Village of River Forest
(2) Concrete Water Reservoir Rehabilitation

January 5, 2026
Addendum No. 1

Attached are Drawings 01 and 02 for the project and the photo album for the 2,000,000 reservoir.

DIXON ENGINEERING, INC.	
River Forest, IL Both Reservoirs	
Hatch Curb	
Drawn By: TMF	Date: 01/05/26
Checked By: JVR	DWG: 01

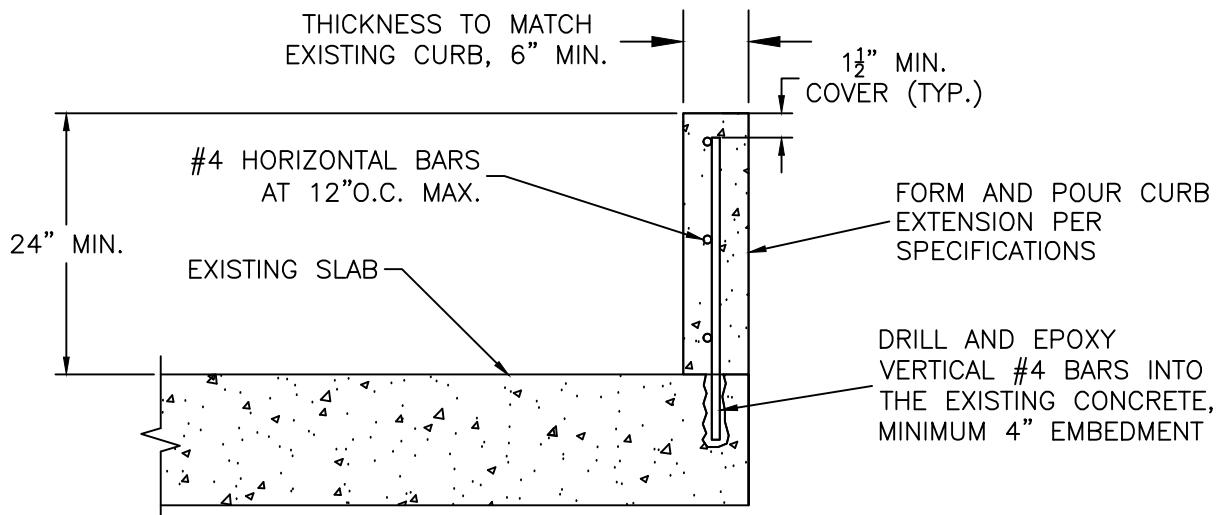
1. THE HORIZONTAL #4 BARS ARE TO BE CONTINUOUS AND WRAP AROUND CORNERS, LAP SPLICES SHALL BE A MINIMUM OF 19 INCHES.
2. NUMBER OF BARS REQUIRED MAY DIFFER FROM DRAWING, FOLLOW THE MAXIMUM SPACING REQUIREMENTS.
